Access Compliance Report

Public Rights-of-Way

(Curb Ramps)

Intersection ID: 3612	Main Street: BRIDLE_RIDGE_LN	Cross Street: FURLONG_TL	Location: SE
ADA ID: 7185AC474E58	Ramp Type: Perp	Initial Pass/Fail: Fail	Overall Compliance: No
		Severity Score: 35

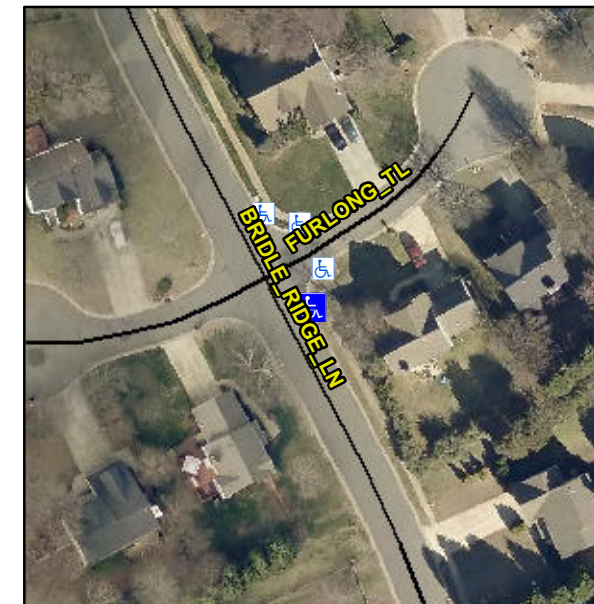
Not Found, R304.5.1, R304.2.2, R304.5.3

Compliance	Description	Data	Compliance	Description	Data
N/A	Ramp Length (in)	50.0	No	Ramp Slope (%)	15.4
No	Ramp Width (in)	45.0	No	Ramp XSlope (%)	4.8
N/A	Flare Type LT	N/A	N/A	Flare Type RT	N/A
N/A	Flare Slope LT (%)	N/A	N/A	Flare Slope RT (%)	N/A
N/A	Flare Traversable LT?	N/A	N/A	Flare Traversable RT?	N/A
N/A	Landing Length (in)	N/A	N/A	DWS Provided?	N/A
N/A	Landing Width (in)	N/A	N/A	DWS Contrast?	N/A
N/A	Landing Slope (%)	N/A	N/A	DWS Length (in)	N/A
N/A	Landing X Slope (%)	N/A	N/A	DWS Full Width?	N/A
N/A	Landing Curb? (Y/N)	N/A	N/A	DWS Offset (in)	N/A
N/A	Shared Landing?	N/A			
N/A	Gutter Ponding?	N/A	N/A	Gutter Slope (%)	N/A
N/A	Gutter Lip Ht (in)	N/A	N/A	Gutter X Slope (%)	N/A
N/A	Painted X Walk1?	No	N/A	Painted X Walk2?	N/A
	X Walk 1 Direction	To SW		X Walk 2 Direction	N/A
N/A	X Walk 1 Width (in)	N/A	N/A	X Walk 2 Width (in)	N/A
	X Walk 1 Slope (%)	4.0		X Walk 2 Slope (%)	N/A
	X Walk 1 X Slope (%)	4.6		X Walk 2 X Slope (%)	N/A

Remove & Replace Entire Ramp.
